Your Reference:
Our Reference: D112461/PJS/td
Date: 26 February 2007

Middleton Lodge Development Planning Application Comments on Hydrogeology and Hydrology

Conjectured Spring Catchments

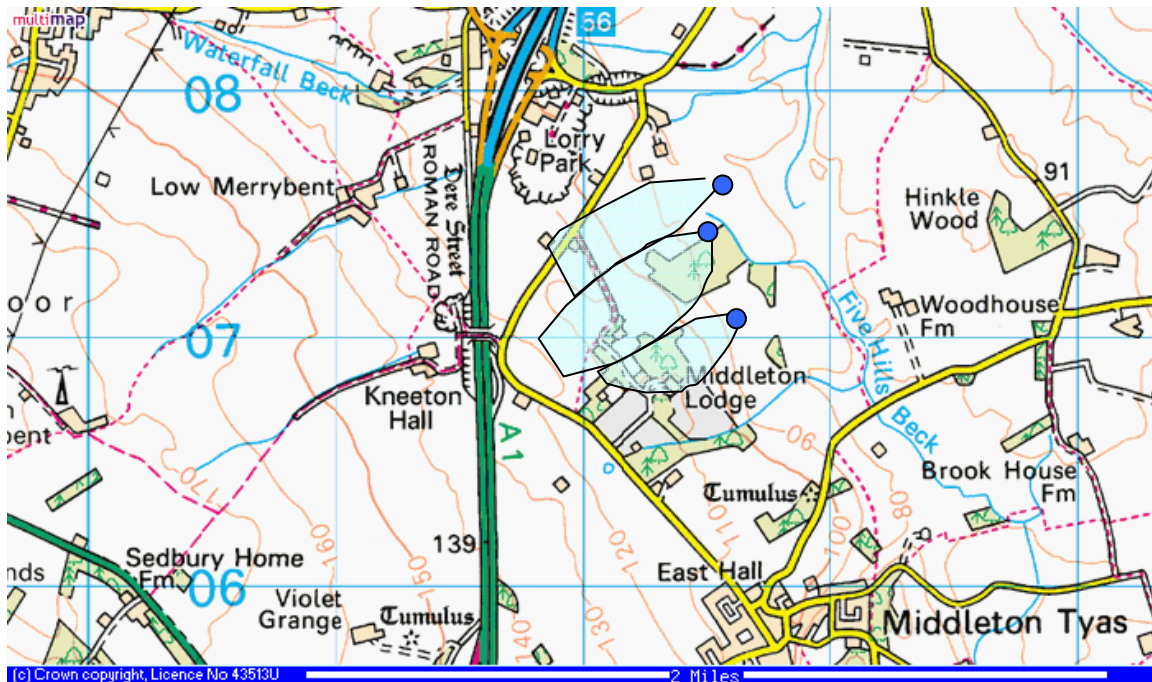
The shape of the spring catchment does not appear to be reasonable. The shape of the catchment is likely to be determined by the underlying geological structure at the base of the limestone sequence / top of the shale; the configuration of this surface dips in a north easterly direction at about 1 in 22. An indicative shape is drawn on the OS 1:50,000 sheet extract overleaf. It is noted that although the quarry development does not occupy a majority of the revised catchment area the development straddles the middle of the catchment. This may not have an impact upon the flow at Acre Howden Spring provided that the water table is low and is not intercepted by the quarrying activity. However if the water surface proved to be higher than anticipated the flow would need to be routed through the proposed system of French drains and infiltration system.
